PCS and RS-FEC LPI behavior

In support of comment #i-104 against D3.0

Adee Ran, Intel Corp.

Figure 82–11—Alignment marker lock state diagram

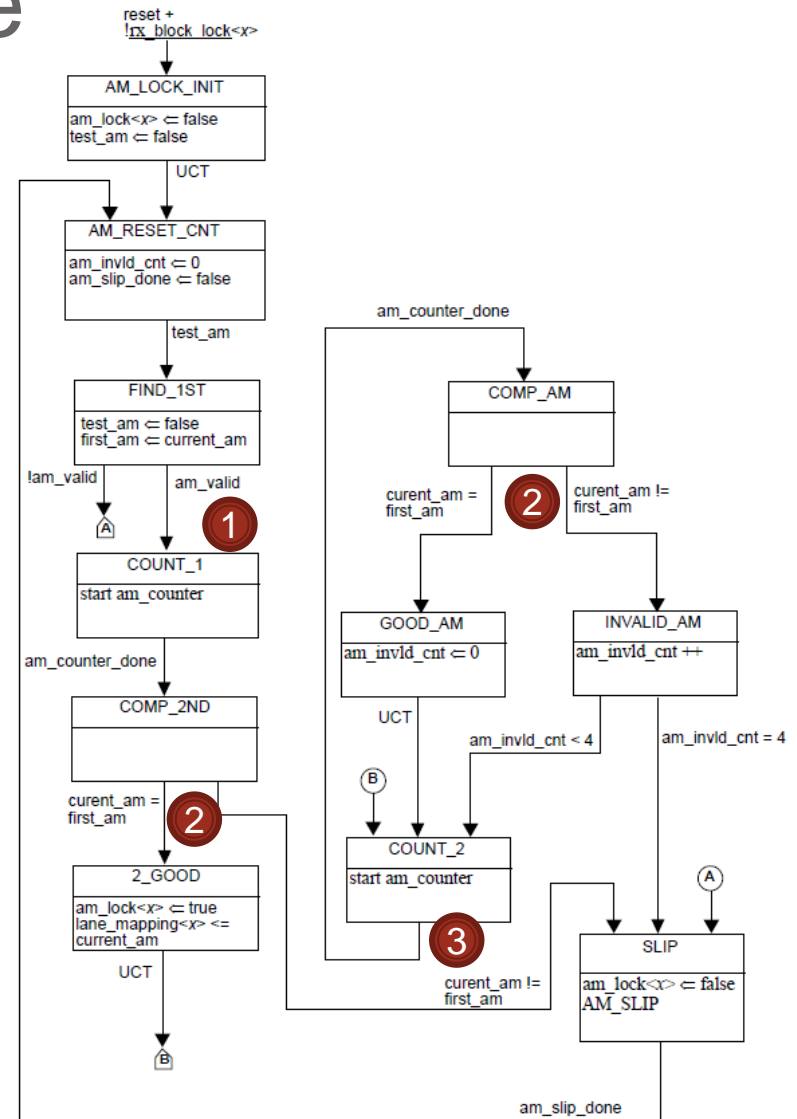
- Current diagram doesn't address RAM→AM transitions and vice versa:
 - RAMs are not valid AMs
 - When first AM occurs after RAMs (e.g. WAKE) comparisons will fail, causing SLIP and setting rx_align_status to FALSE
 - When first RAM occurs (e.g. SLEEP) the process will usually be in COUNT_2; RAM will not cause exit from this state
 - SLIP (and setting rx_align_status to FALSE) will occur after 3-4 AM cycles.
 - If TX goes directly from SLEEP to WAKE (figure 82–16), the 36 RAMs in WAKE may never be detected. AM position will change and alignment will be lost.

Proposed solution

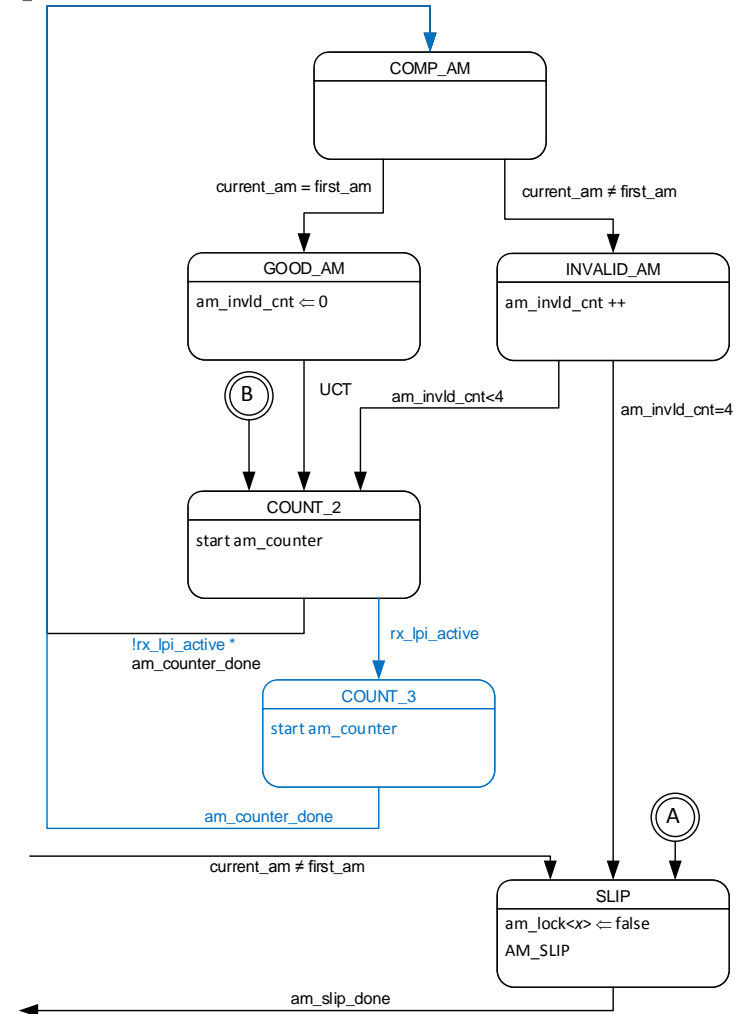
- Required changes:
 - RAM should pass am_valid check.
 - AM and RAM of the same lane should be considered as matching when comparing “current_am=first_am”.
 - First RAM should cause transition out of COUNT_2 state, to restart the counter with a shorter period on SLEEP signaling.
- RS-FEC TX refers to the same diagram, so it should also work there; alignment should be maintained regardless of whether AMs or RAMs are received.
- Detailed solution proposed in next slide.**

- Change variable definitions (in 82.2.18.2.2):
 - **am_valid**: change “...in Table 82–2, ~~or~~ Table 82–3, Table 82–4a or Table 82–4b...”. Delete “~~and it will be repeated every 16384 blocks~~”.
 - **first_am**: A variable that holds the ~~value~~ lane number of the first alignment marker...
 - **current_am**: This variable holds the ~~value~~ lane number of the current alignment marker...
- Modify the right-hand side of figure 82-11 as shown.
 - New state COUNT_3 causes am_counter to restart in sync with transition of rx_lpi_active.

Figure 82–17—LPI Receive state diagram

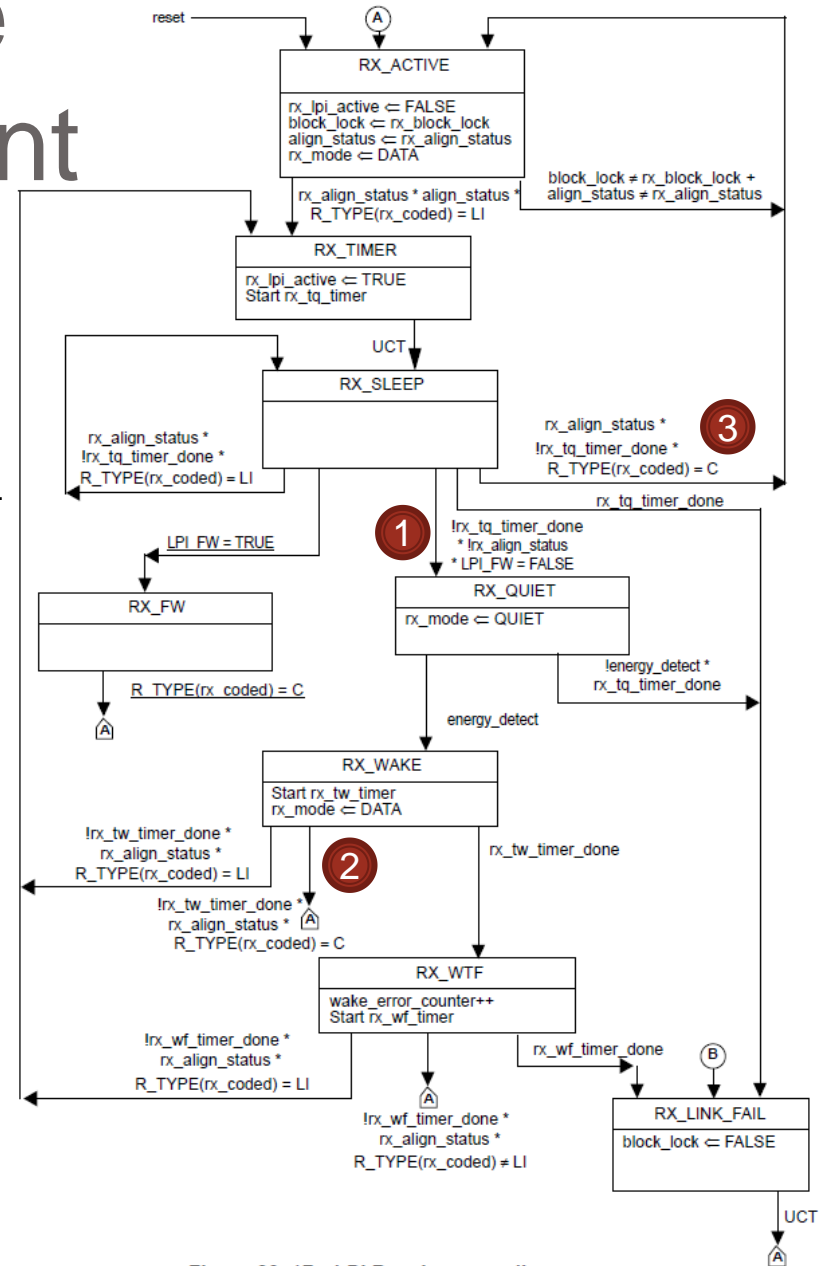
1. The transition $RX_SLEEP \rightarrow RX_QUIET$ should occur only after transmitter stops sending RAMs (no energy); **otherwise a premature transition to RX_WAKE would occur.**
 - rx_align_status must be held TRUE while RAMs are received.
2. “ rx_lpi_active should be *synchronized by and inferred from* RAMs”
 - rx_lpi_active is changed during the $RX_WAKE \rightarrow RX_ACTIVE$ transition. Currently this happens when R_TYPE is C (IDLE) – before RAMs change to Ams – so is not synchronized.
 - rx_down_count can be used for this purpose instead.
3. The $RX_SLEEP \rightarrow RX_ACTIVE$ transition is also unsynchronized with AMs.
 - Note: no equivalent scenario in PCS TX diagram (always goes through TX_WAKE).
